2018 Changes to International Codes

IBC - STRUCTURAL - STRUCTURAL TAC

2018 International Building Code – Structural

Structural TAC

FIGURE 1609.3-1609.3(1) (1)
ULTIMATE-BASIC DESIGN WIND SPEEDS, v_{ult} , FOR RISK CATEGORY II BUILDINGS AND OTHER STRUCTURES

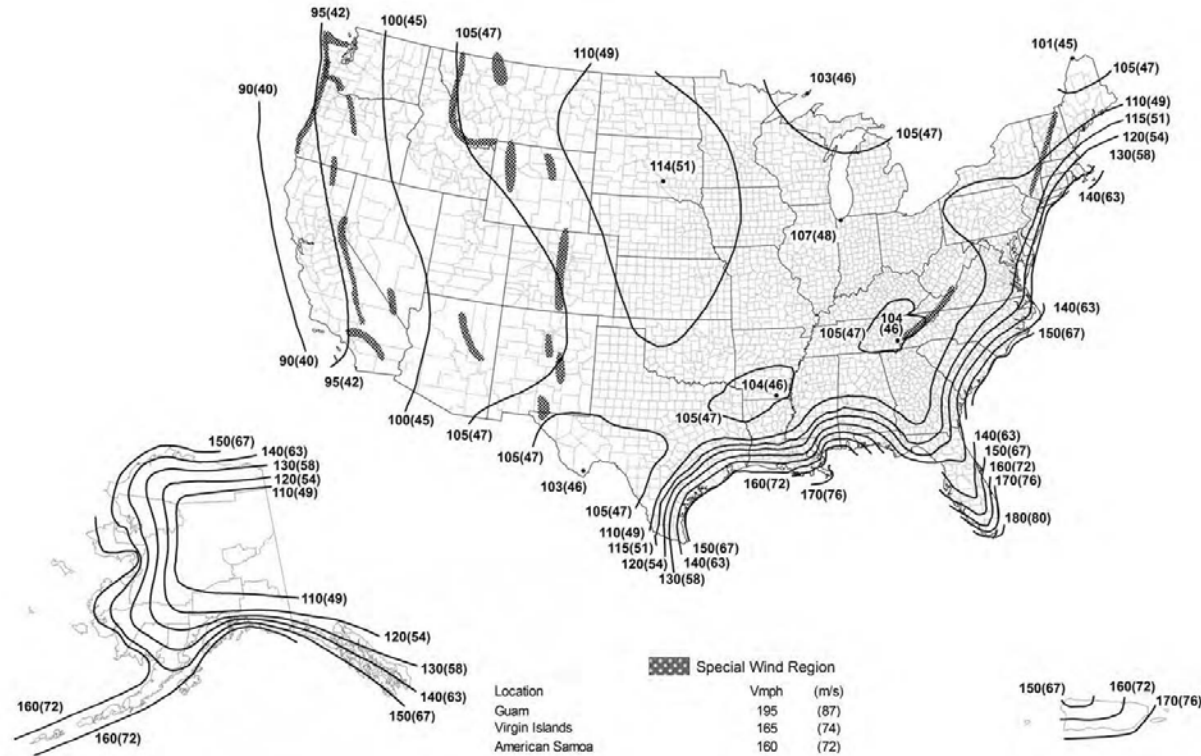
1609.3 ~~Ultimate-Basic~~ design wind speed. The ~~ultimate-basic~~ design wind speed, V_{ult} , in mph, for the determination of the wind loads shall be determined by Figures 1609.3(1), ~~1609.3(2)~~ and ~~1609.3(3)~~ through (8). The ~~ultimate-basic~~ design wind speed, V_{ult} , for use in the design of Risk Category II buildings and structures shall be obtained from Figure 1609.3(1) and (5). The ~~ultimate-basic~~ design wind speed, V_{ult} , for use in the design of Risk Category III buildings and structures shall be obtained from Figure 1609.3(2) and (6). The basic design wind speed, V , for use in the design of Risk Category IV buildings and structures shall be obtained from Figure ~~1609.3(2)~~ 1609.3(3) and (7). The ~~ultimate basic~~ design wind speed, V_{ult} , for use in the design of Risk Category I buildings and structures shall be obtained from Figure ~~1609.3(3)~~ 1609.3(4) and (8). The ~~ultimate-basic~~ design wind speed, V_{ult} , for the special wind regions indicated near mountainous terrain and near gorges shall be in accordance with local jurisdiction requirements. The ~~ultimate-basic~~ design wind speeds, V_{ult} , determined by the local jurisdiction shall be in accordance with ~~Section 26.5.4~~ Chapter 26 of ASCE 7.

Delete and substitute as follows:

FIGURE 1609.3-1609.3(2) (2)
ULTIMATE BASIC DESIGN WIND SPEEDS, V_{ult} , FOR RISK CATEGORY III AND IV BUILDINGS AND OTHER STRUCTURES

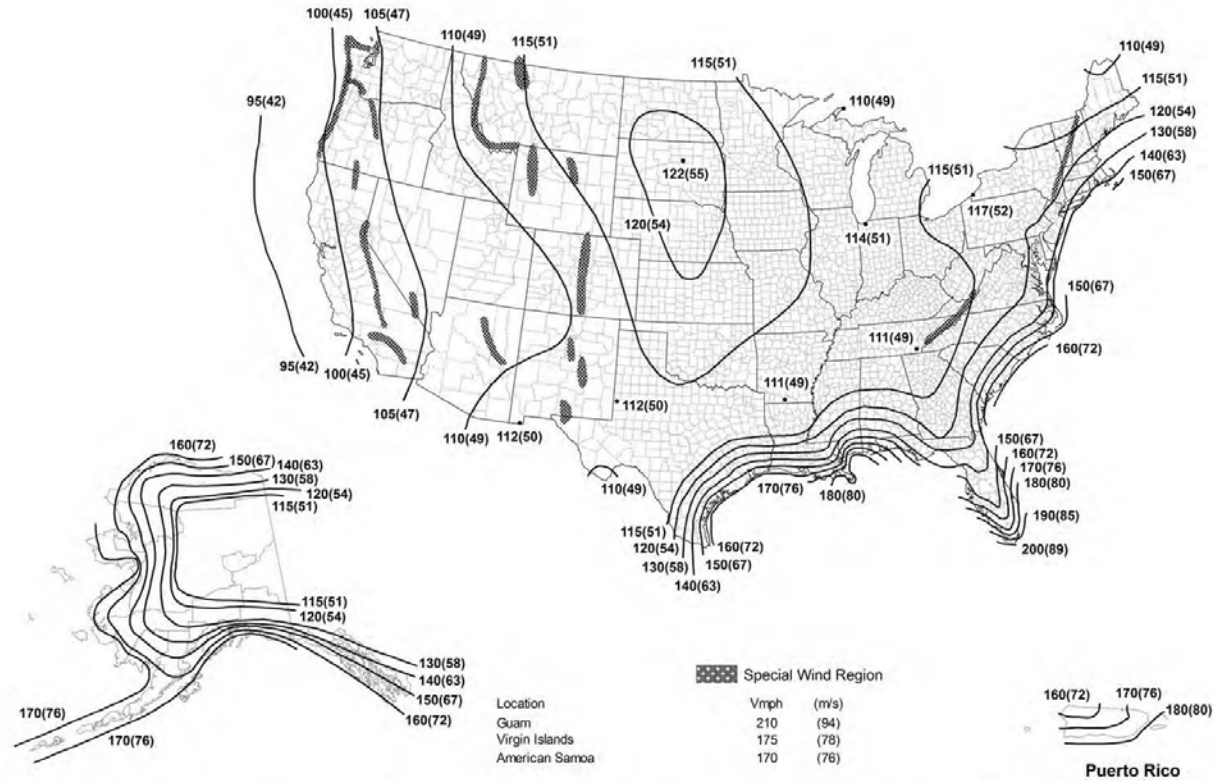
Revise as follows:

FIGURE 1609.3(3)
BASIC DESIGN WIND SPEEDS, V, FOR RISK CATEGORY IV BUILDINGS AND OTHER STRUCTURES

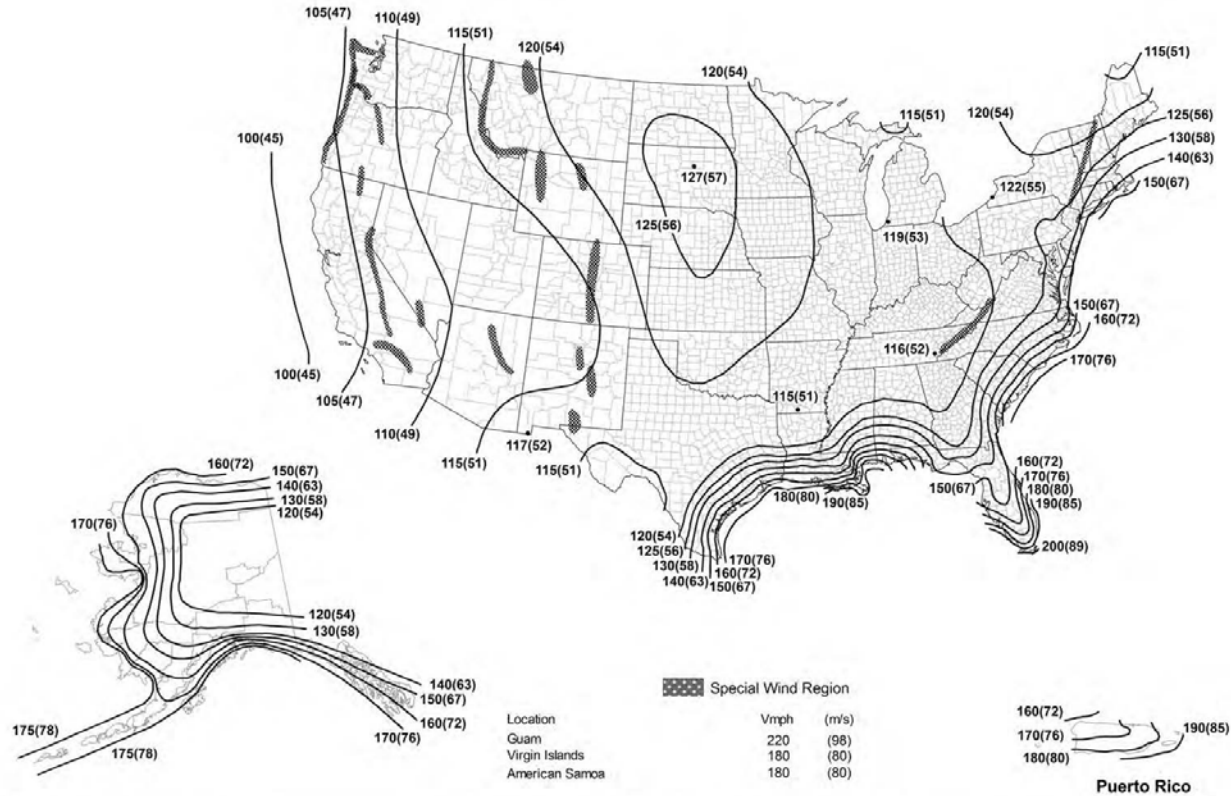
Add new text as follows:

FIGURE 1609.31609.3(4) (3)
ULTIMATE BASIC DESIGN WIND SPEEDS, v_{ult} , FOR RISK CATEGORY I BUILDINGS AND OTHER STRUCTURES

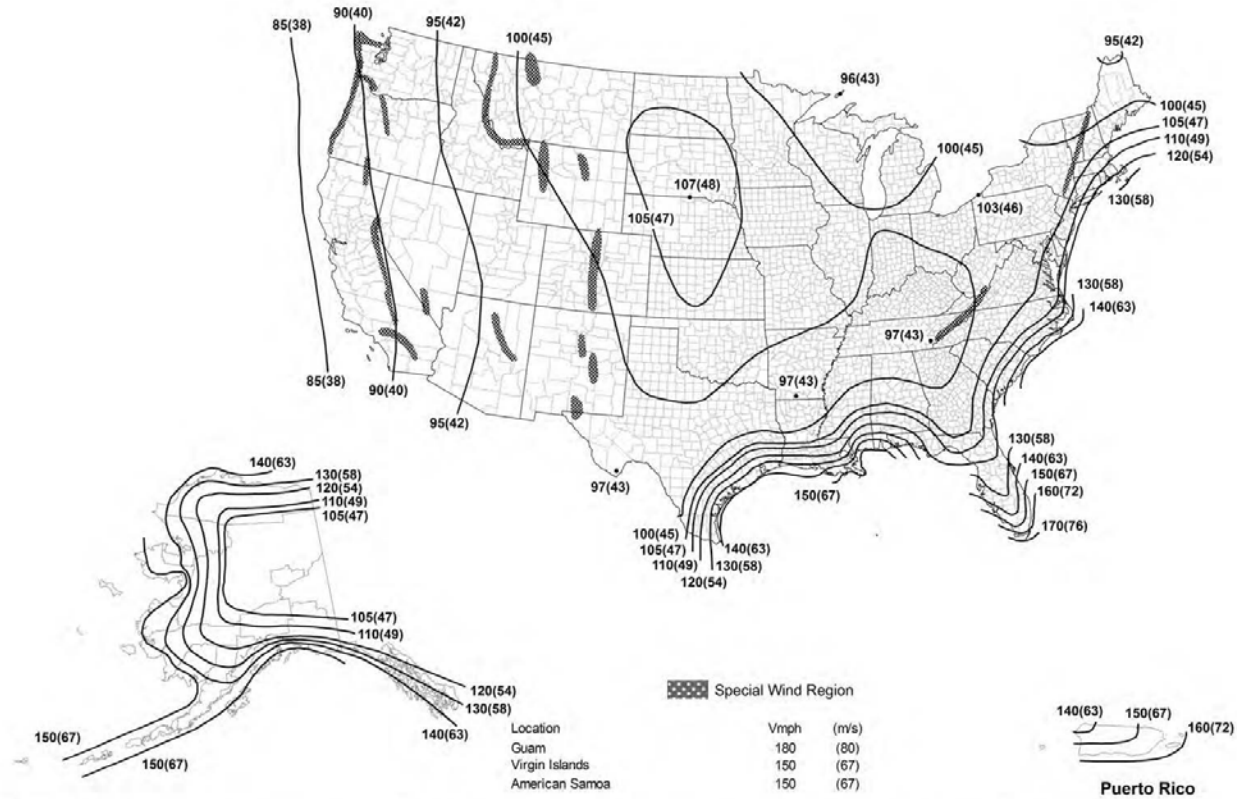
Delete and substitute as follows:

FIGURE 1609.3(5)
BASIC DESIGN WIND SPEEDS, V, FOR RISK CATEGORY II BUILDINGS AND OTHER STRUCTURES IN HAWAII

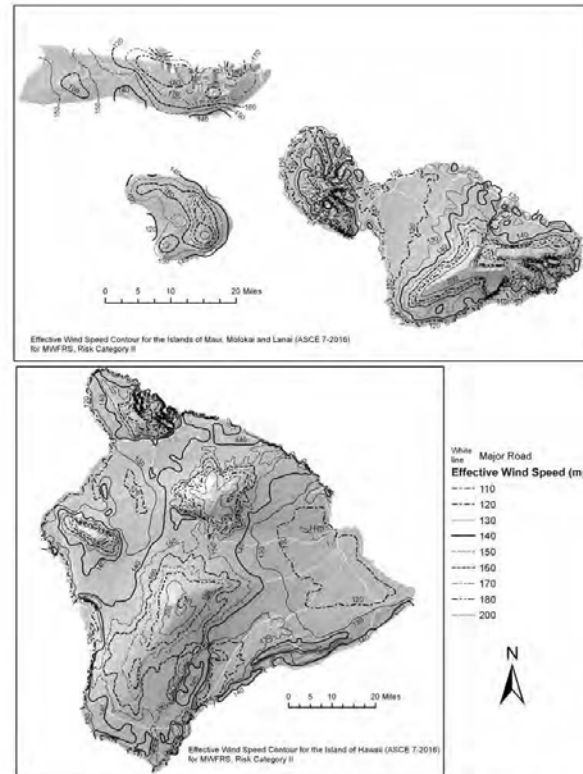
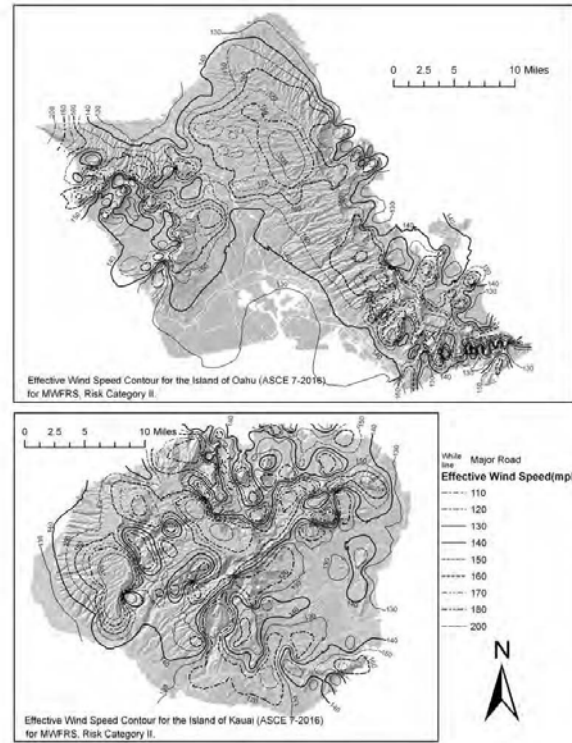
<p>DESIGN WIND SPEEDS, V, FOR RISK CATEGORY II BUILDINGS AND OTHER STRUCTURES IN HAWAII”, FIGURE 1609.3(6) “BASIC DESIGN WIND SPEEDS, V, FOR RISK CATEGORY III BUILDINGS AND OTHER STRUCTURES IN HAWAII”, FIGURE 1609.3(7) “BASIC DESIGN WIND SPEEDS, V, FOR RISK CATEGORY IV BUILDINGS AND OTHER STRUCTURES IN HAWAII”, FIGURE 1609.3(8) “BASIC DESIGN WIND SPEEDS, V, FOR RISK CATEGORY I BUILDINGS AND OTHER STRUCTURES IN HAWAII”.</p> <p>This proposal is a coordination proposal to bring the 2018 IBC up to date with the provision of the 2016 edition of ASCE 7</p> <p>Minimum Design Loads and Associated Criteria for Buildings and Other Structures (ASCE 7-16). The changes proposed in all sections harmonizes terminology between the code and the loading standard. In all instances the word "ultimate" is changed to "basic" and the subscript "ult" is removed from the variable "V". Similarly, the word "nominal" is changed to "allowable stress" in all places to be consistent with the terminology used in the loading standard. The increase in distance in 1609.1.1.1 Applicability to 2 miles from 1 mile is also to correct the discrepancy between the code and ASCE 7. The design wind speed maps have been updated to reflect the maps adopted into ASCE 7-16.</p> <p>Currently there are eight new maps for main wind force and component and cladding design in the ASCE 7-16 standard along with four new serviceability map. The code change was further modified by the Committee. The modification picks up additional coordination with IBC wind requirements that were not in the original proposal.</p> <p>Cost Impact: Will not increase the cost of construction. The proposed map changes will decrease the cost of construction in the majority of the United States. The basic design wind speeds have been lowered at most locations on the new</p>

Add new text as follows:

FIGURE 1613.3.4-1613.3.1(1)-1 (1)
RISK-TARGETED MAXIMUM CONSIDERED EARTHQUAKE (MCE_R) GROUND MOTION RESPONSE ACCELERATIONS FOR THE CONTERMINOUS UNITED STATES OF 0.2-SECOND SPECTRAL RESPONSE ACCELERATION (5% OF CRITICAL DAMPING), SITE CLASS B

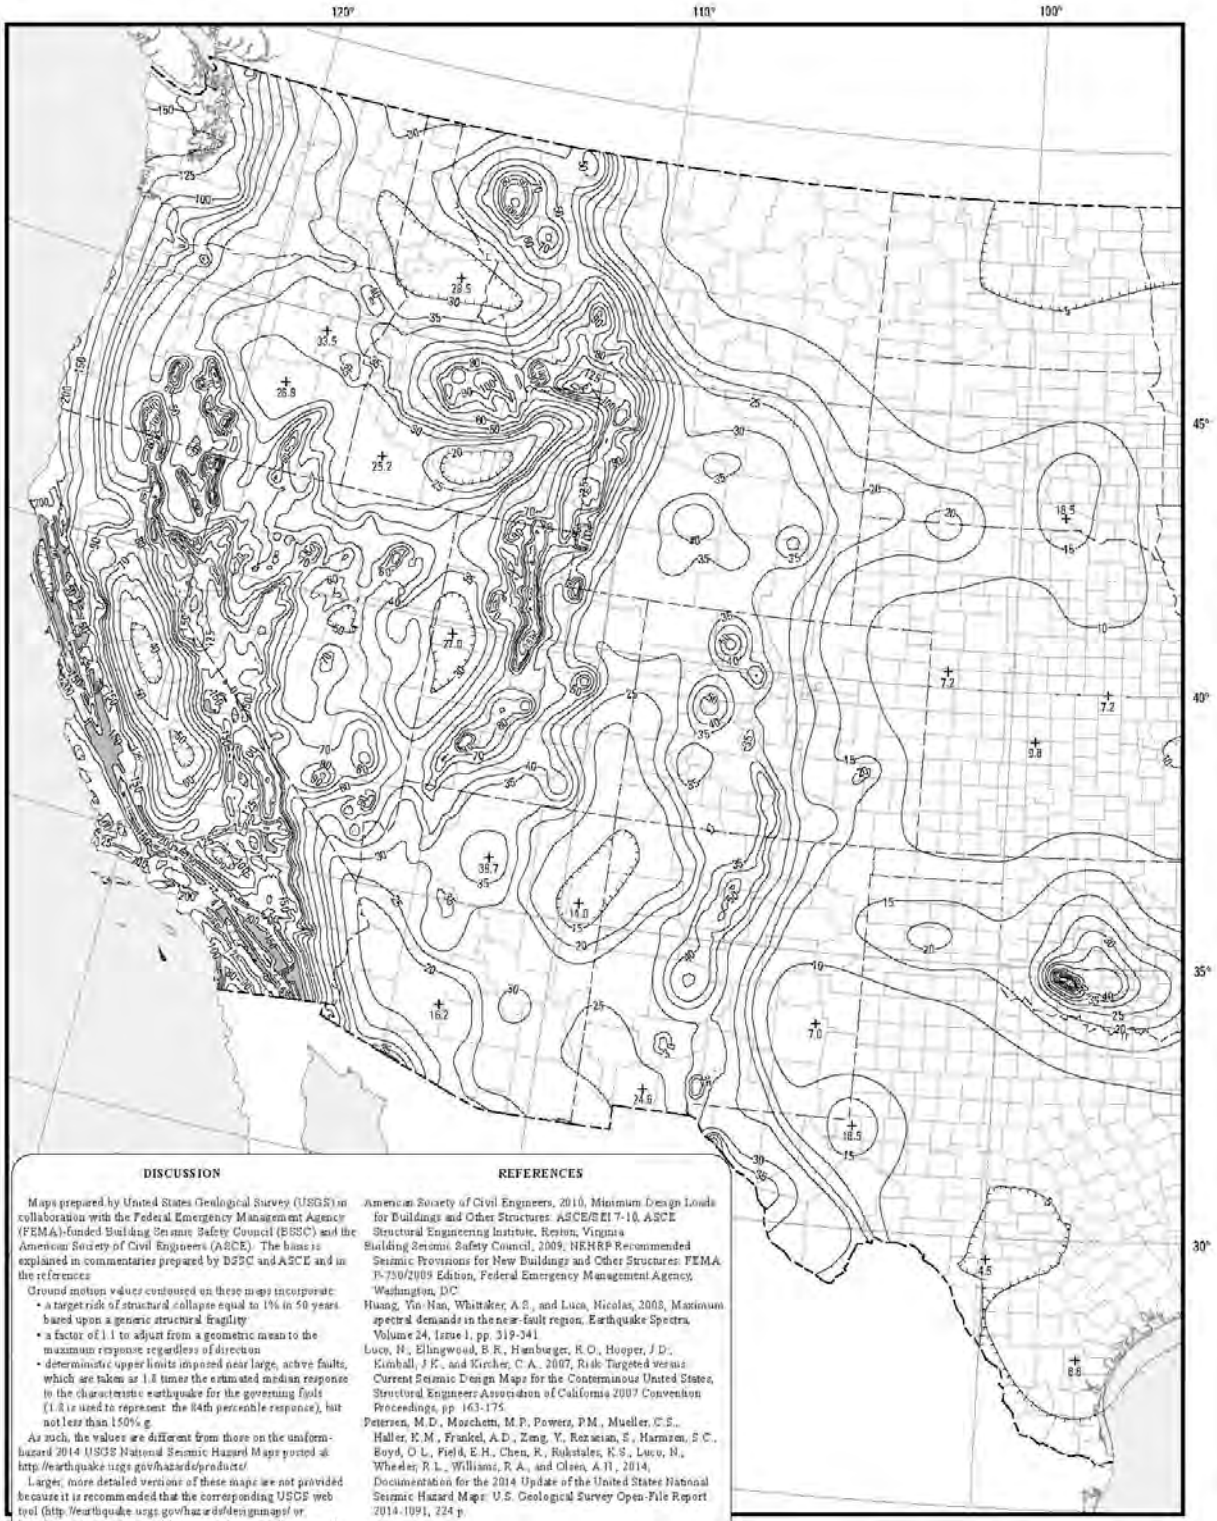
Revise as follows:

Reason: This proposal incorporates the most recent seismic design maps prepared by the U.S. Geological Survey (USGS) in collaboration with the Federal Emergency Management Agency (FEMA) and the Building Seismic Safety Council (BSSC). The proposed maps are consistent with those incorporated into the NEHRP Provisions (FEMA P-1050-1, 2015) and ASCE 7-16. The proposed maps incorporate significant new information on earthquake faults and ground motion attenuation, and are more consistent with the site-specific ground motion procedures of ASCE 7-16 Chapter 21. Technical reasons behind the changes are documented in FEMA P-1050-1, Section C22. Further documentation is provided in Luco et al. (2015) and companion papers in a special issue of *Earthquake Spectra* (2015).

FIGURE 2308.5.5.1(1)
Single Member Header in Exterior Bearing Wall

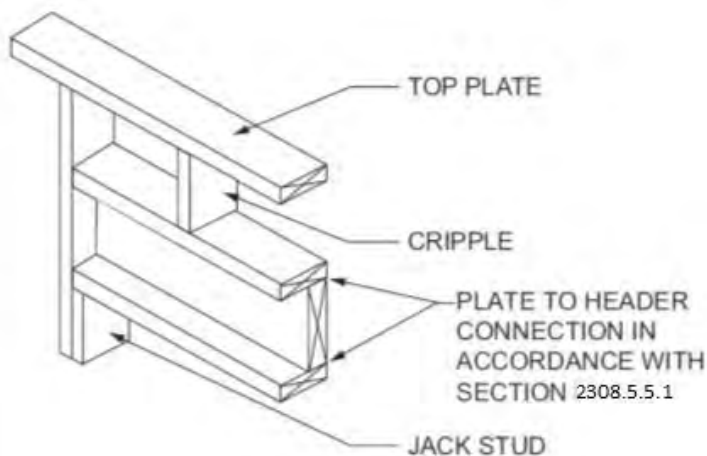
<p>S292-16</p>	<p>2308.5.5.1, 2308.5.5.1(1) (New), 2308.5.5.1(2) (New)</p>	<p>Modifies text of Section 2308.5.5.1 “Openings in exterior bearing walls”. Adds Figure 2308.5.5.1(1) “Single Member Header in Exterior Bearing Wall” and Figure 2308.5.5.1(2) “Alternative Single Member Header Without Cripple”. This proposal adds prescriptive framing and connection requirements for single member (single ply) headers consistent with the IRC. Additionally, provisions of 2308.5.5.1 are revised to coordinate with tabulated header sizes consisting of 2, 3, or 4 member headers.</p> <p>Cost Impact: Will not increase the cost of construction. This change adds a more efficient single member header option in some cases and will not raise the cost of construction.</p>	<p>Same as change between 2015 IBC-B and 2018 IBC-B</p>

Add new text as follows:

Reason: This proposal adds prescriptive framing and connection requirements for single member (single ply) headers consistent with the IRC. Additionally, provisions of 2308.5.5.1 are revised to coordinate with tabulated header sizes consisting of 2, 3, or 4 member headers.
